CITY OF DANIA BEACH CITY COMMISSION MEETING
JANUARY 12, 2021 at 7:00 PM
VIRTUAL MEETING AND PUBLIC COMMENTS PROCEDURE

90 WAVE
PREPARED FOR
DANIA BEACH MARINE CORP.
CITY OF DANIA BEACH, FLORIDA

FIGURE 8
BACKGROUND BRYAN ROAD 2-WAY VOLUMES
DANIA MARINA
144706000

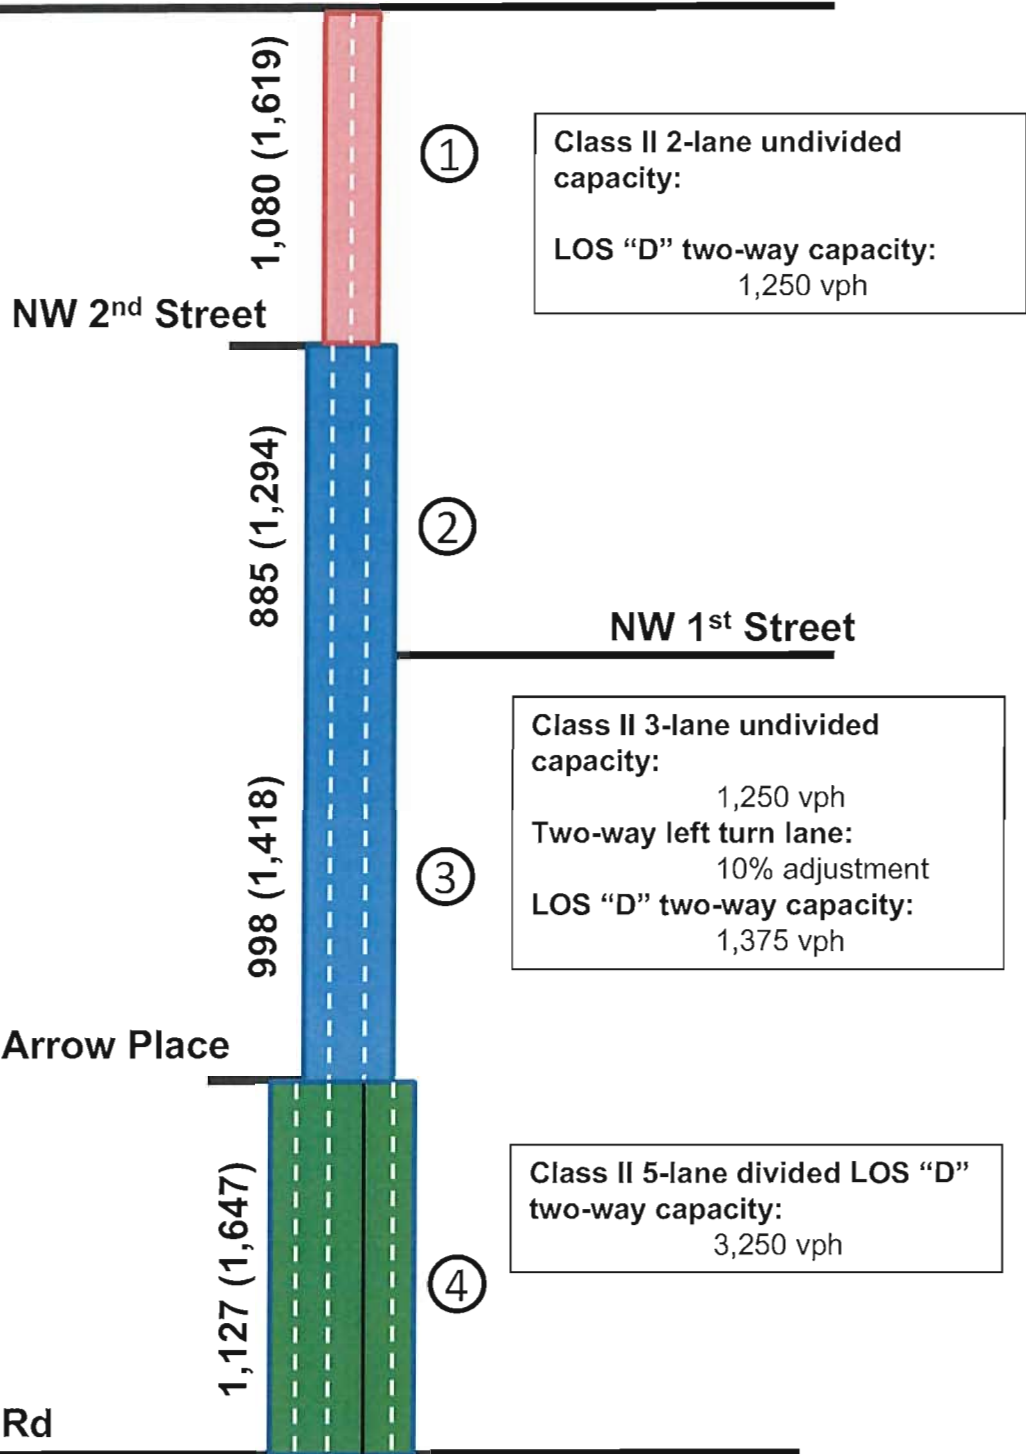
Comment) In Figure 8, please revise the AM peak 2-way volume north of Stirling Road.

Response) *The volume shown in Figure 8 is correct and the 2-way volumes for background AM peak hour north of Stirling Road were correct, however, the volume development sheet had incorrectly referenced committed trips from 150 S Bryan and has been updated to the correct values.*

FIGURE 10
SITE DRIVEWAY VOLUMES
DANIA MARINA
144706000

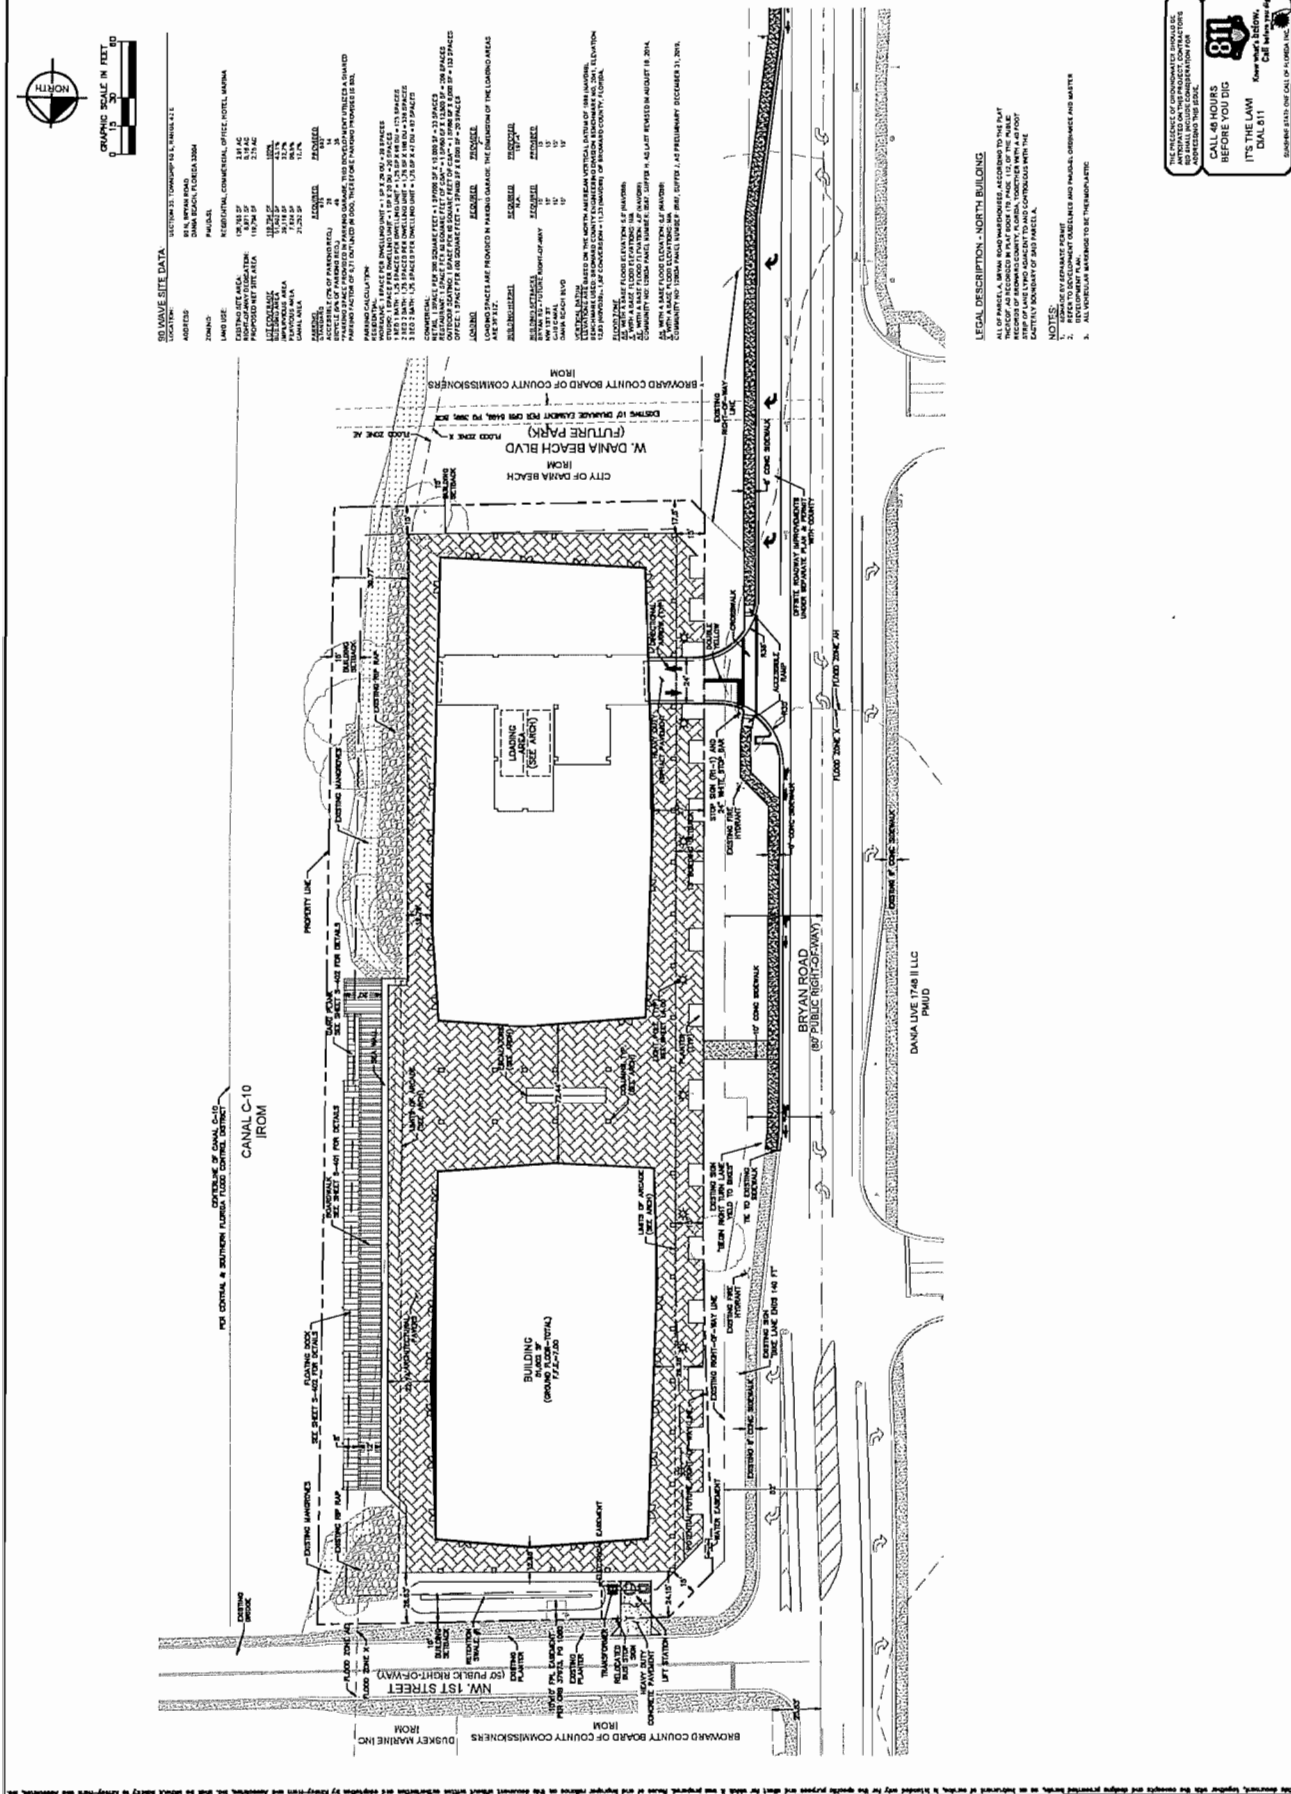
Comment) Please revise the volumes in the AM analysis of the North driveway consistent with Figure 10.

Comment) Please revise the volumes in the AM and PM analyses of the south driveway consistent with Figure 10.

Response) *The volumes for the north driveway have been revised in Figure 10 in the updated analysis.*

Response) *The AM and PM future Synchro analysis has been updated to properly reflect those volumes shown in Figure 10.*

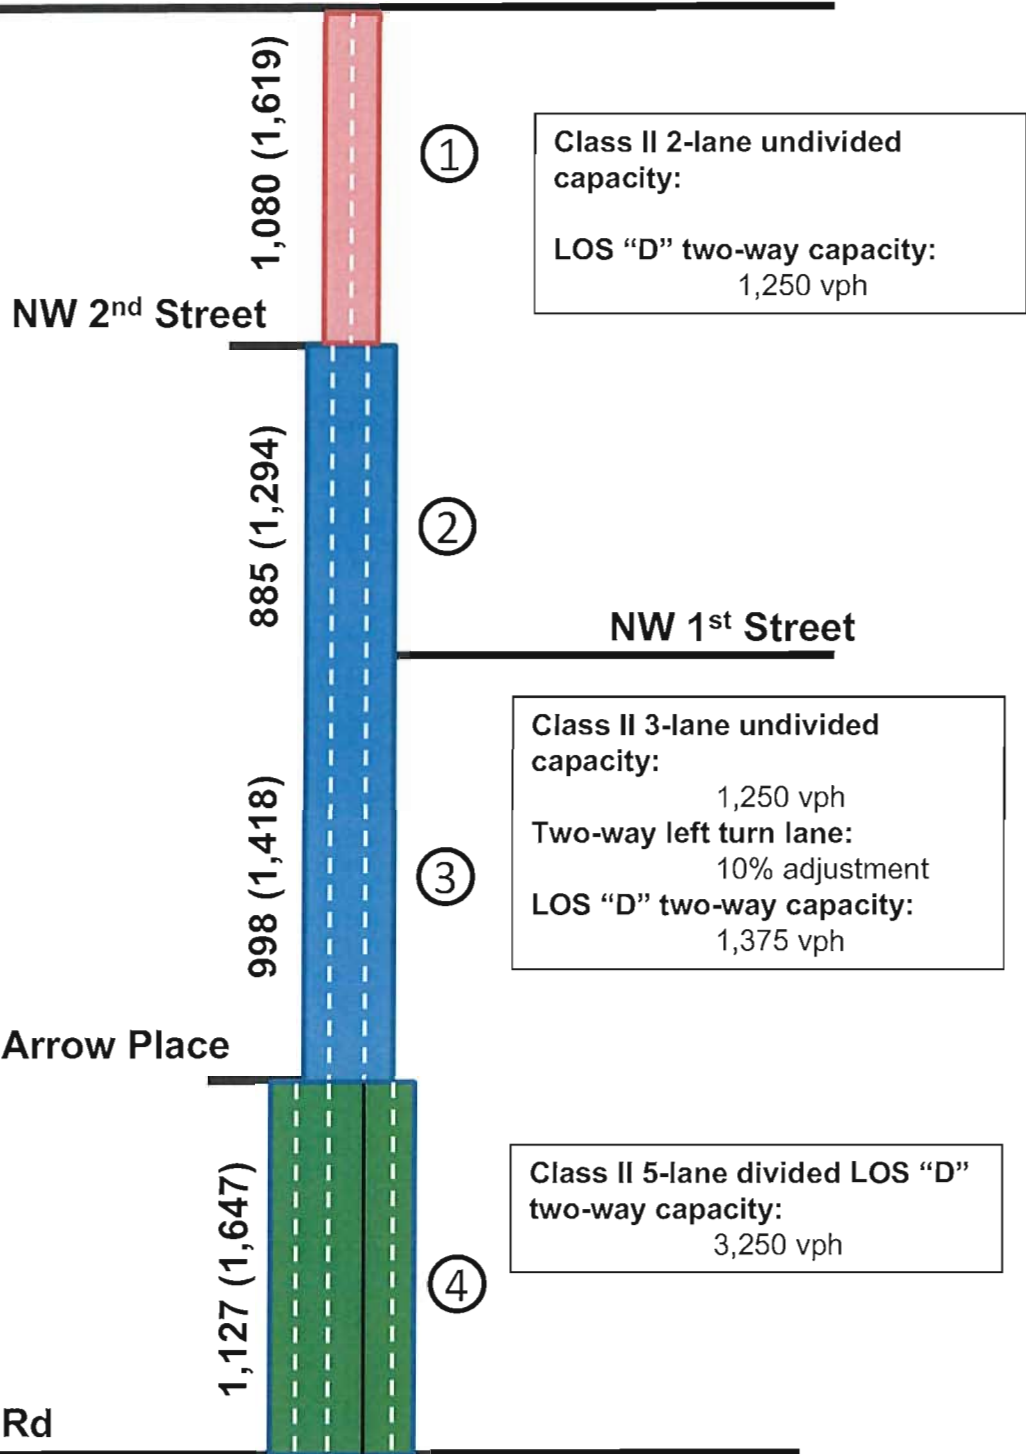
Comment) In Figure 8, please revise the AM peak 2-way volume north of Stirling Road.

Response) *The volume shown in Figure 8 is correct and the 2-way volumes for background AM peak hour north of Stirling Road were correct, however, the volume development sheet had incorrectly referenced committed trips from 150 S Bryan and has been updated to the correct values.*

FIGURE 10
SITE DRIVEWAY VOLUMES
DANIA MARINA
144706000

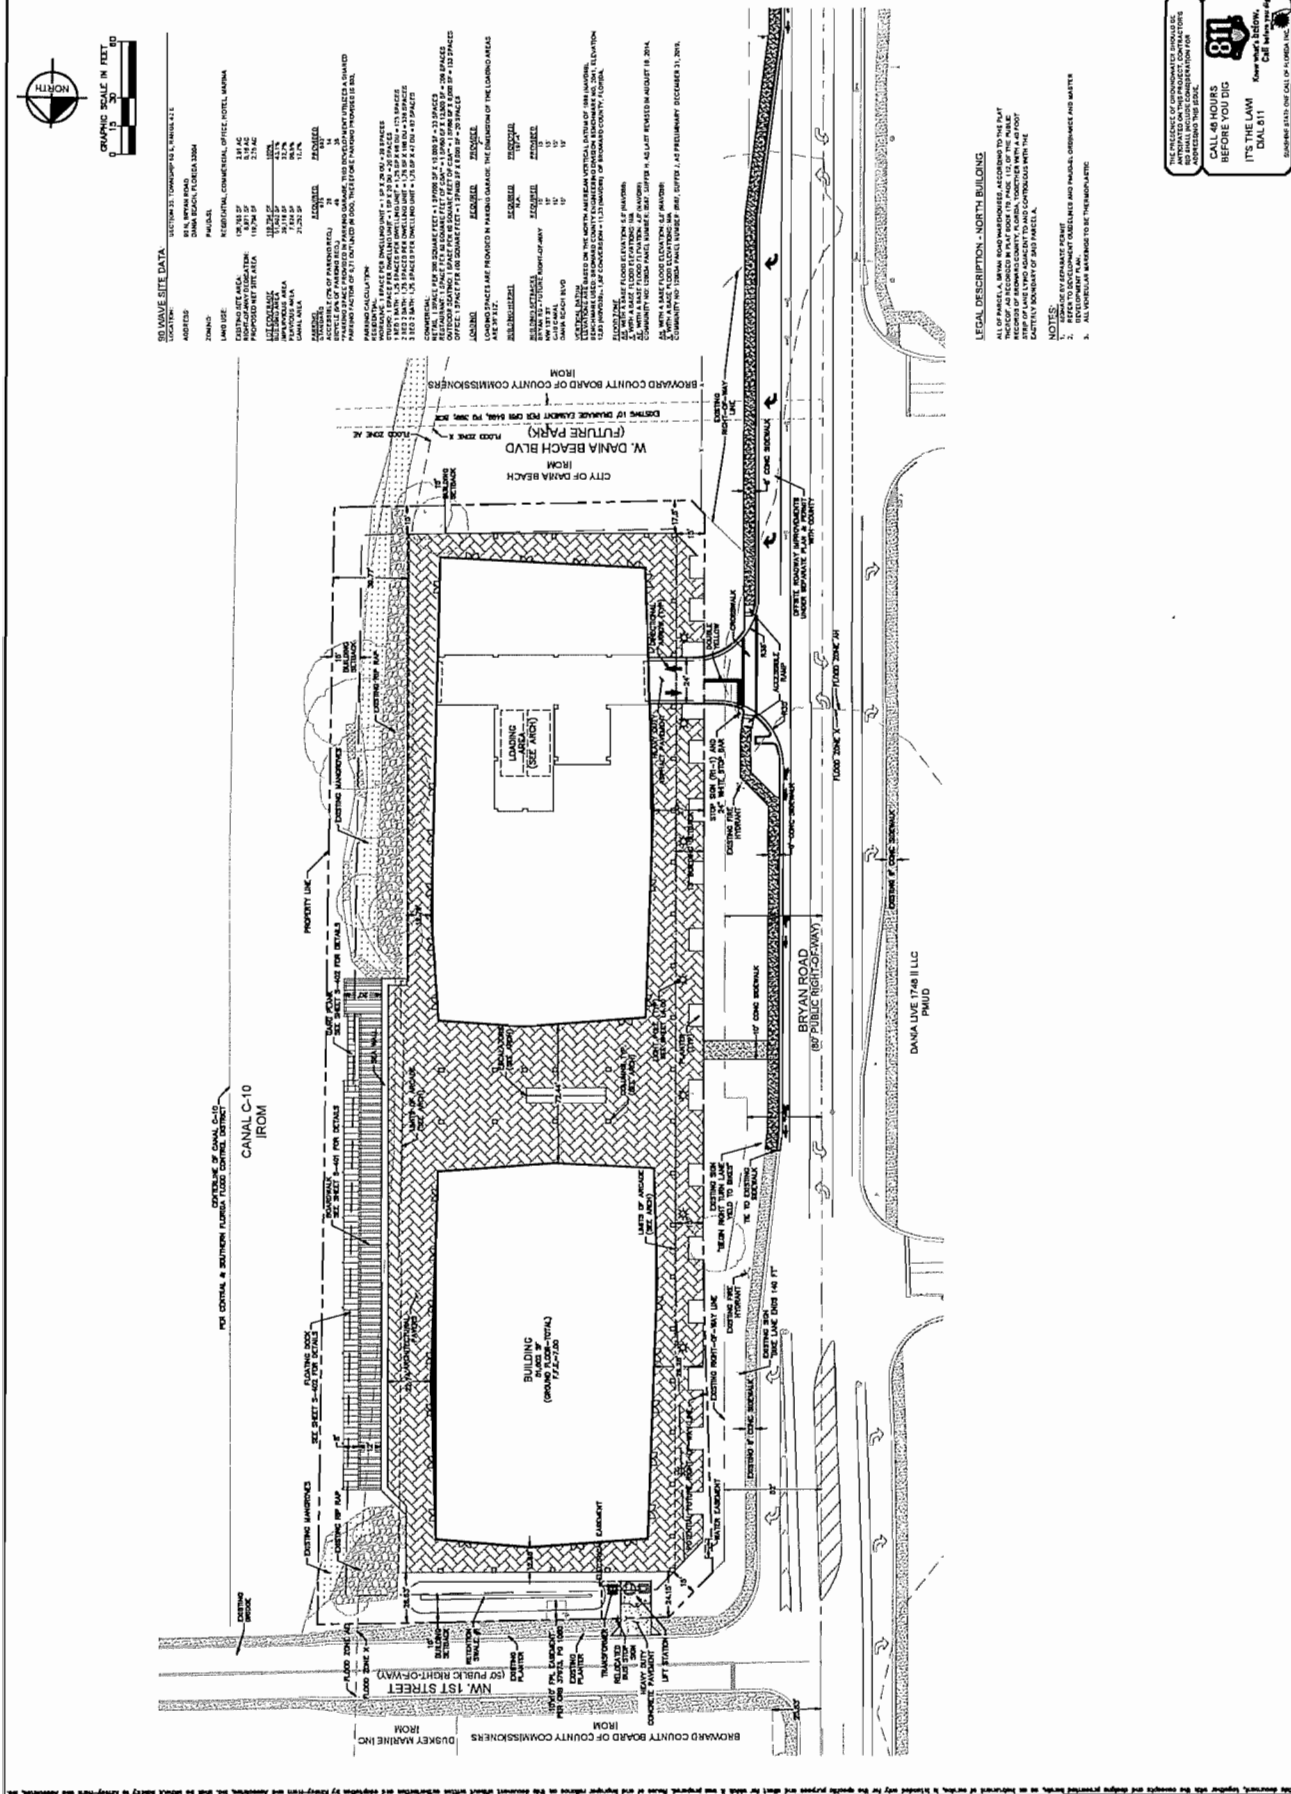
Comment) Please revise the volumes in the AM analysis of the North driveway consistent with Figure 10.

Comment) Please revise the volumes in the AM and PM analyses of the south driveway consistent with Figure 10.

Response) *The volumes for the north driveway have been revised in Figure 10 in the updated analysis.*

Response) *The AM and PM future Synchro analysis has been updated to properly reflect those volumes shown in Figure 10.*
